Mountain Shadows Community Association's
January 17, 2021 Assessment of
Hillside Development Guidelines Manual, reprinted 2000
<https://coloradosprings.gov/sites/default/files/planning/dab/hillside.pdf>
and Hillside Overlay
<https://coloradosprings.gov/planning-and-development/page/hillside-overlay>
Regarding
2424 Garden of the Gods
Project Statement, Revised November 2020
with
Proposed Concept Plan, Zone Change, and Master Plan Amendment

Mountain Shadows Community Association (MSCA) is opposed to the proposed Concept Plan, Zone Change, and Master Plan Amendment because the proposed plan will not comply with stipulations in the Hillside Development Guidelines Manual.

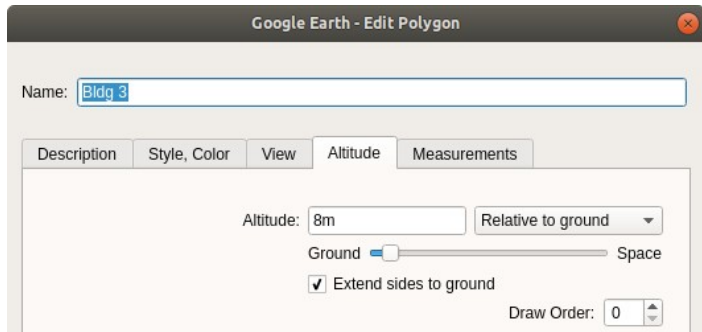
While the proposed maximum building height is 45 feet, a building that is 25 feet tall will block the views of the natural ridgeline and will NOT fit in with the design of this community.

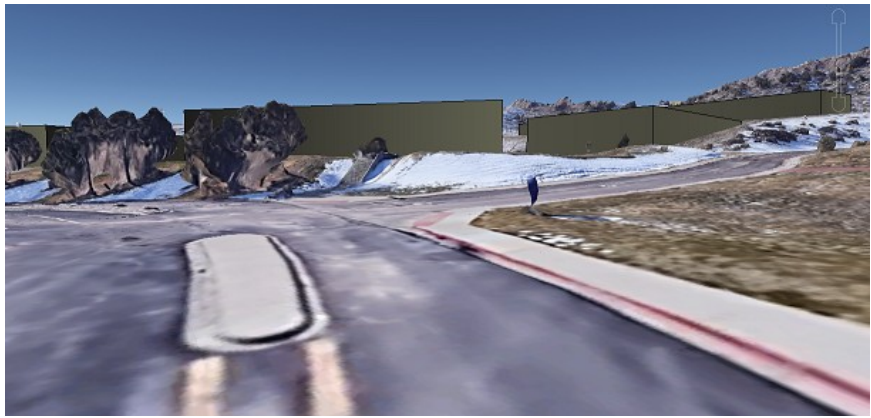
To further validate the previous artist renditions and Google Earth Pro measurements, polygon structures were defined in Google Earth Pro with the parameter of 8 meters (26 ft.) and relative to ground. The maximum height of the building are specified at 26 feet which means, if there is an uphill side to the building, that side will be lower than 26 feet.

Even with the structures defined to be 26 feet tall, they substantially **block the view of the natural ridgeline**. The image below contains the Google Earth polygon structures and is oriented facing southwest. The view is between the parking lot adjacent to N. 30th St. and the southeast side of the current facility.
